Planning Commission Hearing Staff Report

McDonald's Design Review for Rebuild
Conditional Building and Site Design Review
(Petition 430-08-01)
1533 South State Street
Re-hearing date: July 30, 2008

A ELEVATION NORTH SIDE - KENSINGTON AVE.
 SCALE: 1/4" = 1'-0"

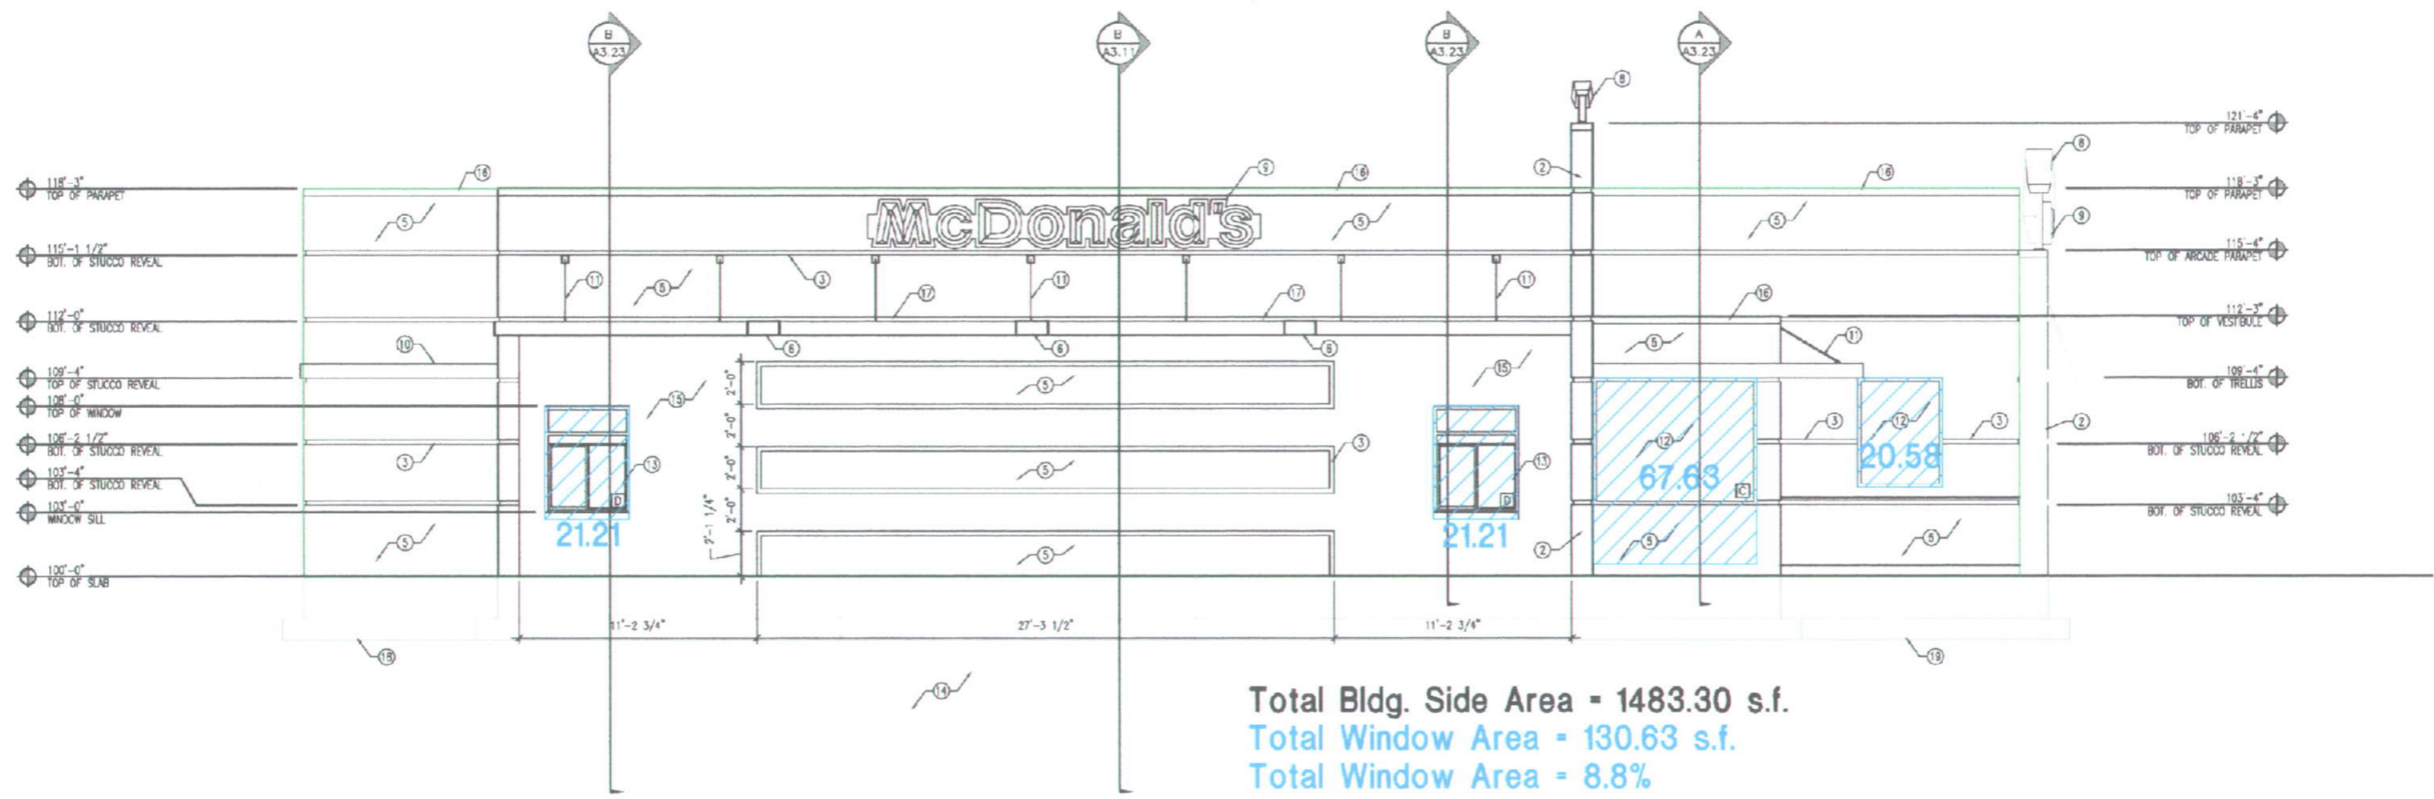
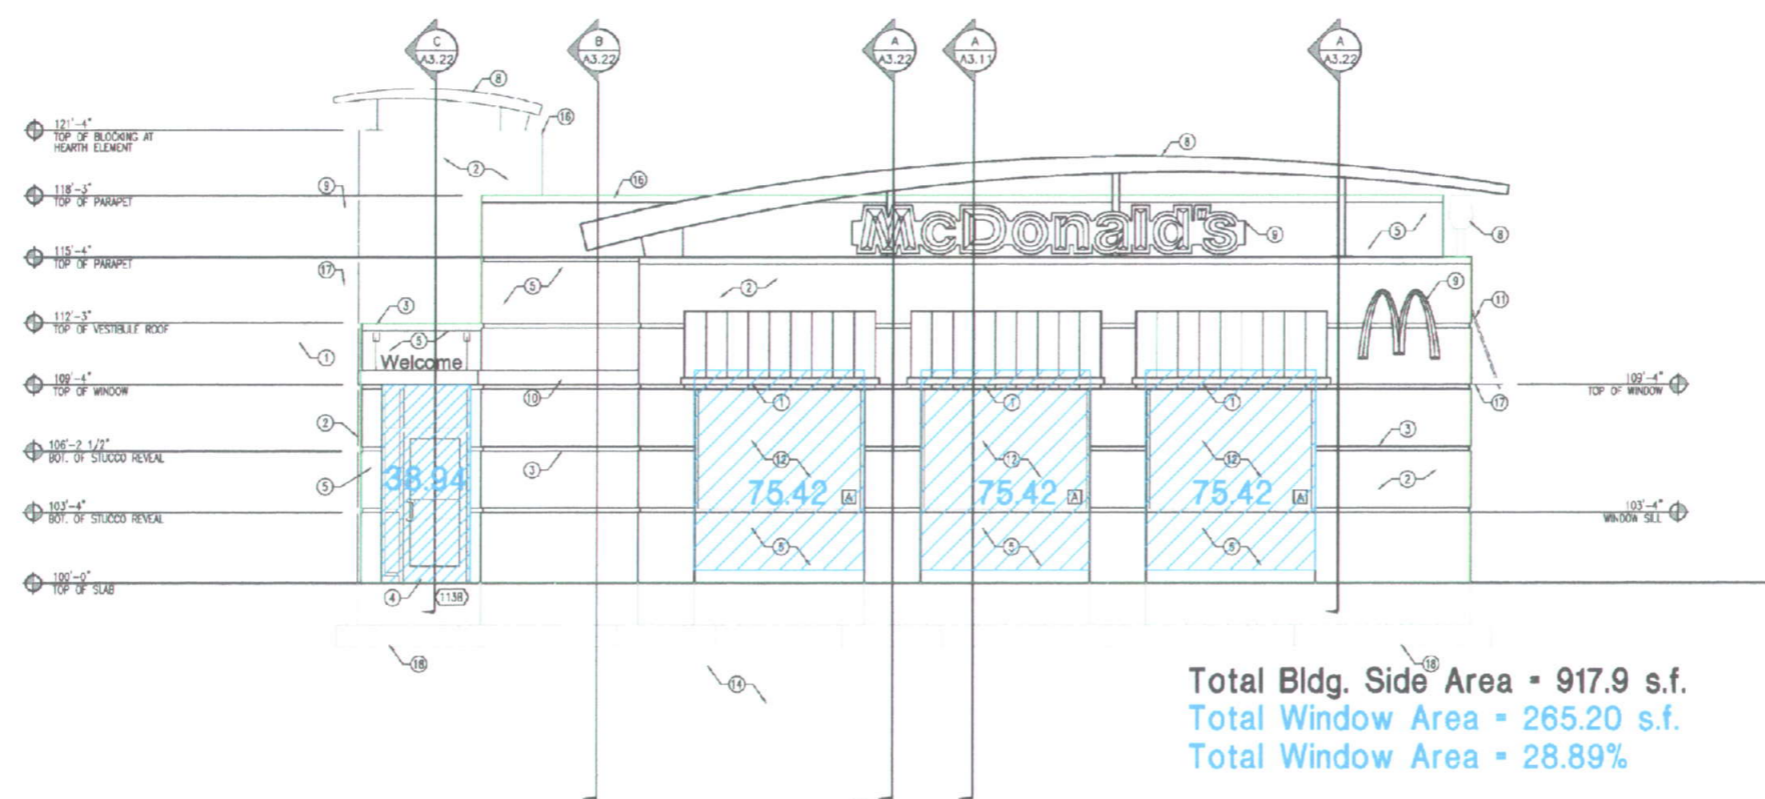
The applicant has revised the building façade along State Street to achieve a glass content of approximately 29% (up from 18%); and the façade along Kensington Avenue to achieve approximately 9% glass content (up from 7%). The optional dumpster location is in the northeast corner of the site, near the vehicle access onto Kensington Avenue. The landscape plan has been revised to include more native trees, shrubs, and groundcover (see sheet LS-1 of site drawings). No other building location options were provided.

- Minimum First Floor Glass (*21A.34.090.F.1*): The building facades facing State Street and Kensington are required to have a minimum of forty percent (40%) non-reflective glass. The proposed façade along Kensington Avenue, which is the drive-through side of the building, has been revised from approximately seven percent (7%) glass at the first hearing on June 11, 2008, to approximately nine percent (9%) glass. The proposed façade along State Street has been revised from approximately eighteen percent (18%) glass at the first hearing, to approximately 29% glass.

Staff recognizes the applicant's efforts in the revised drawings to increase the glass content along State Street. However, staff continues to find no hardship preventing 40% glass content on the west façade (State Street). In considering the aforementioned option of rotating the building and locating the drive-through lane on the east façade, the applicant could provide more glass content on the north (Kensington) and west (State Street) facades. This would be one more aspect whereby the project meets the intent of the SSSC Overlay and conforms to current ordinances.

Total Bldg. Side Area = 1483.30 s.f.
 Total Window Area = 130.63 s.f.
 Total Window Area = 8.8%

Total Bldg. Side Area = 917.9 s.f.
 Total Window Area = 265.20 s.f.
 Total Window Area = 28.89%

LS-1

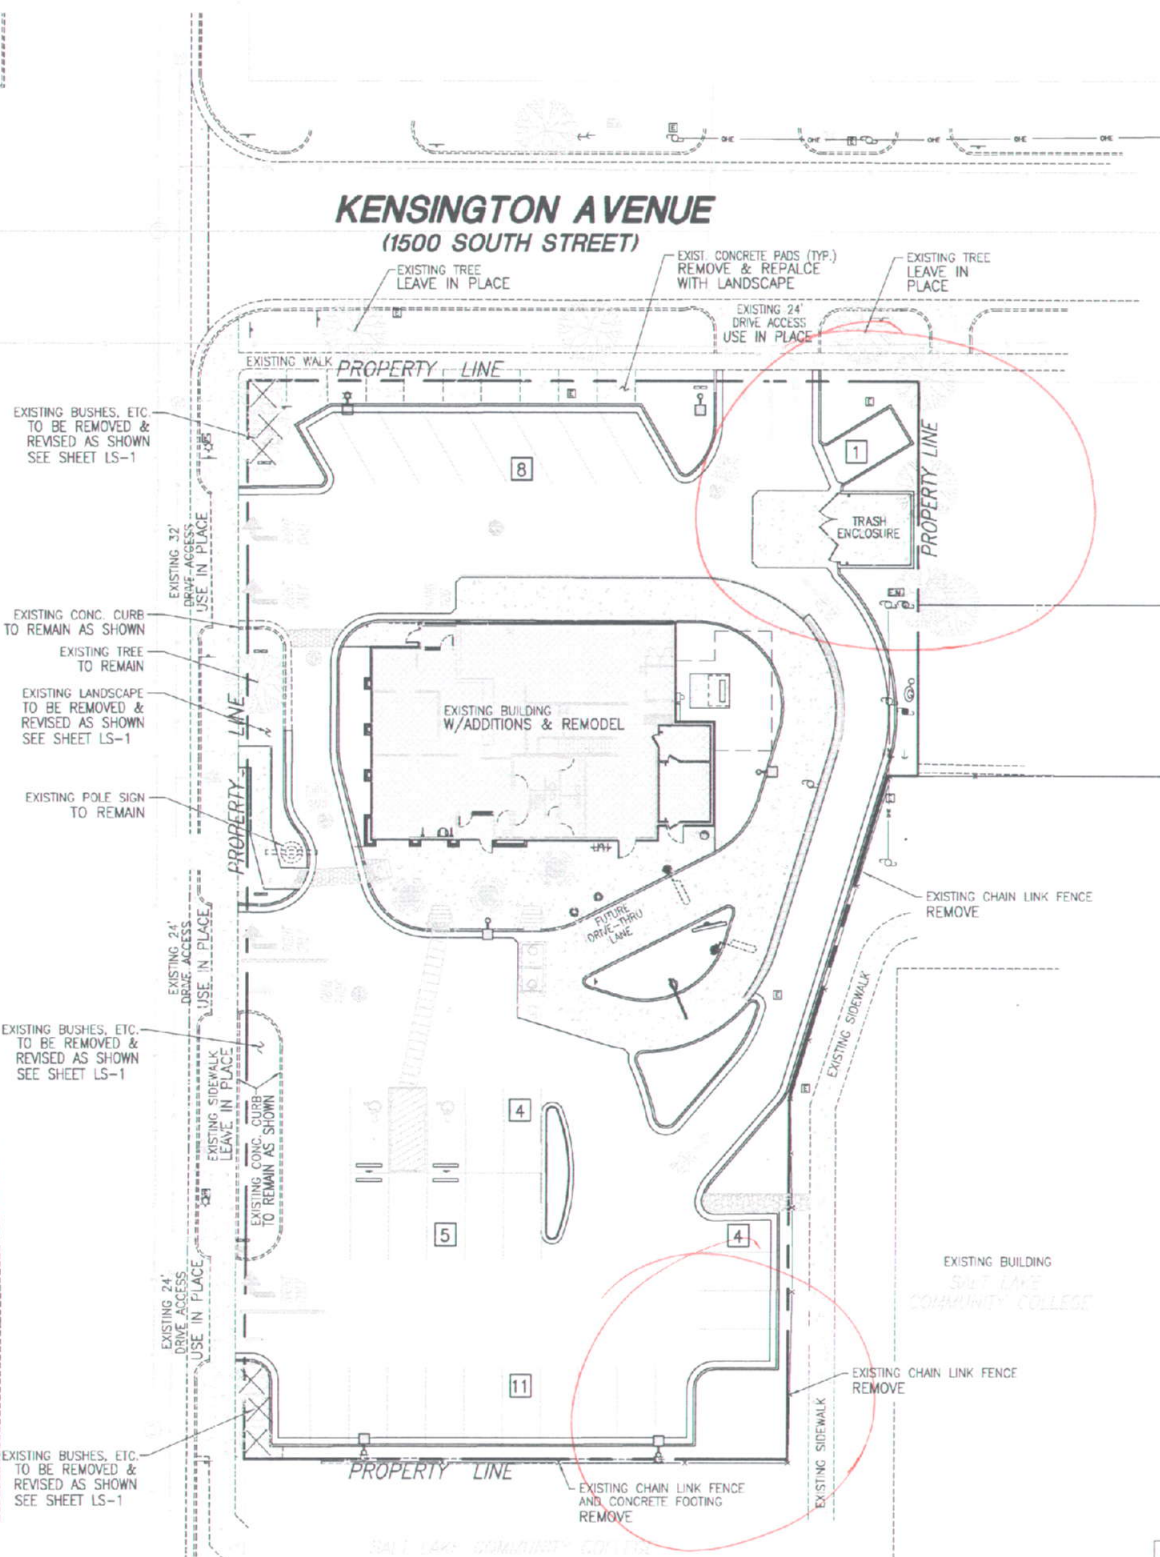
In this case, the excess parking is not needed. Between seven (7) and ten (10) stalls, depending on the size of the outdoor dining area, could be removed and the parking lot layout revised to increase the width of the perimeter landscaped areas to 7 feet in the extreme southwest corner and the two parking areas along the east property line. Given the small size of the parking area north of the building, and the existing landscaped park strip, staff supports the requested reduction of the perimeter landscape buffer along Kensington Avenue.

Analysis: The parking lots will be similar to the existing design, with some modifications to enhance the drive-through system and increase landscaping on the site. The perimeter parking lot landscaping along State Street and Kensington will be enhanced with additional shade trees and more shrubs in sufficient quantity to meet the landscaping requirements. The total amount of landscaped area will increase by approximately 1,800 square feet (3,944 sq ft to be increased to 5,736 sq ft). The redevelopment does not provide sufficient landscaping buffer width on the east lot line near the residentially zoned lots owned by the Salt Lake Community College or south property line. The Landscaping Ordinance stipulates a 7-foot perimeter parking lot buffer whenever the parking lot is within 20 feet of property lines. The landscape buffer proposed is approximately four feet. The existing site does not meet the ordinance but, with the redevelopment, will come closer to meeting the ordinance. The improvements and enhancements proposed by the applicant will increase the screening of the parking lot and increase the total amount of landscaping on the site.

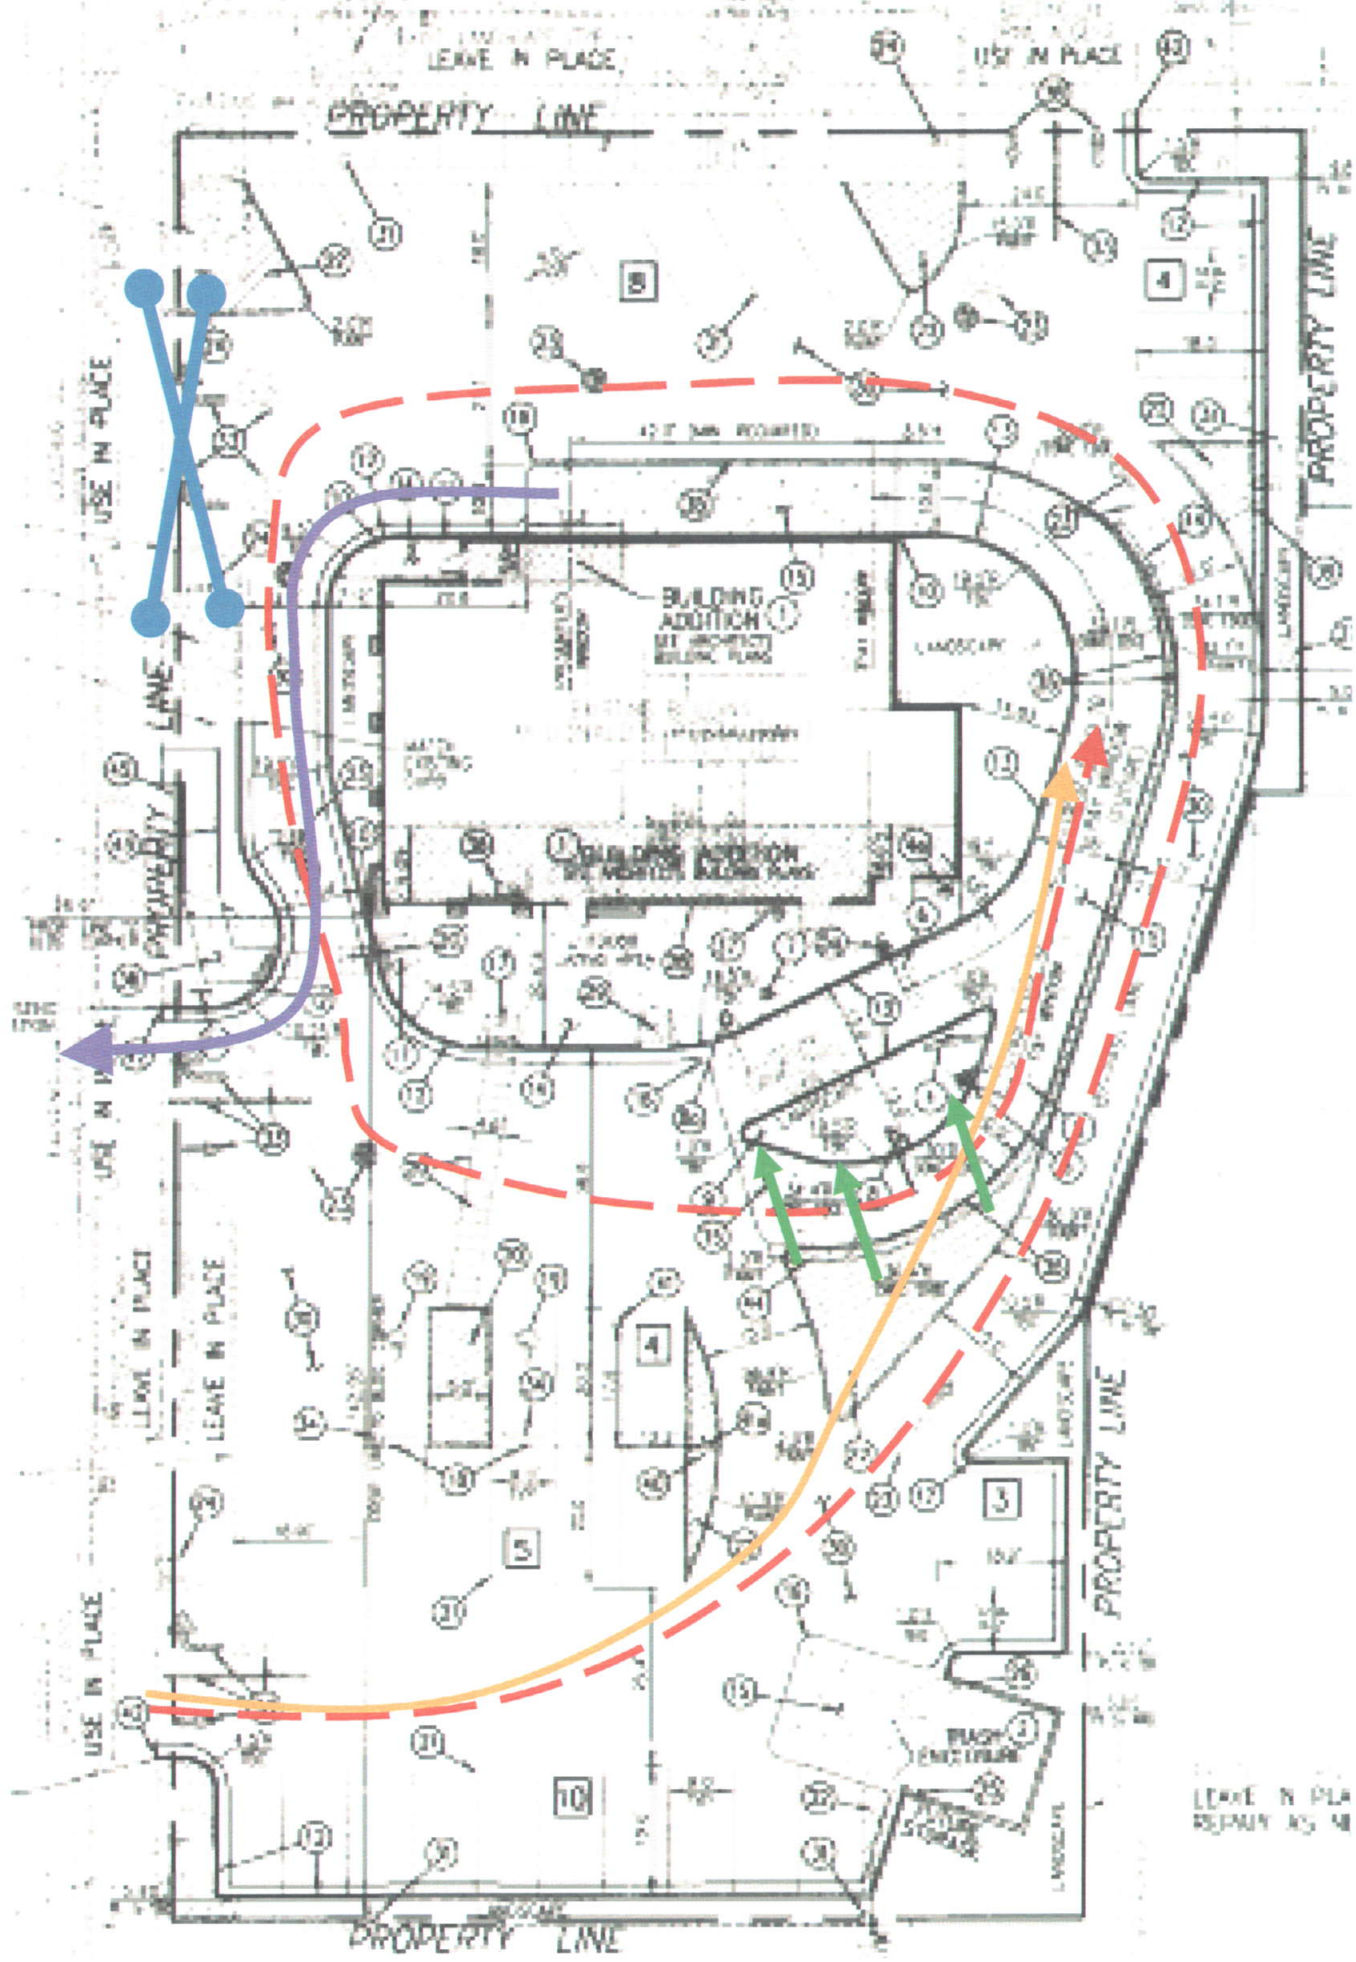
There is a lot of automobile congestion at this site and I don't think that this plan addresses it appropriately.

1. The red line shows the proper traffic flow (as proposed) for someone entering in the first driveway entrance coming from the South to the North, it is ridiculous. The proper flow to reduce congestion should be to along the yellow line. The proposed landscaping should be moved to increase the size of the center island (green arrows).

3. As the second drive up order lane is only "proposed" and may never go in, what landscaping will they add in its place until such time they decide to install it? In my opinion they should just install the two drive up system now as there is a long line of traffic in the mornings (before class) and at noon. (This is also why I would recommend that the first drive through lane be accessed from the South drive as there it provides more room on the site to stack automobiles away from the front door)
